## **Addendum #1**

February 23, 2018

Re: Gym Floor Refinishing 2018  
Pre-Bid Meeting Notes

4J Gym Refinishing 2/23/18  
Addendum Sketch - Churchill

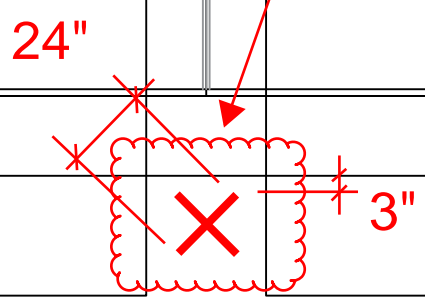
Please see the attached attendance roster from our non-mandatory pre-bid visit to the site. The one change discussed was the additional painting of a few lines at Churchill HS as shown on the attached drawing.

Provide 3/4" wood colored paint lines on both sides of 2" imaginary center line.

(2" Center line doesn't continue through logo.)

Provide 27" long x1" painted white coach lines adjacent to both Aisles.

Provide 24" long x1" painted white 'X' for substitutes
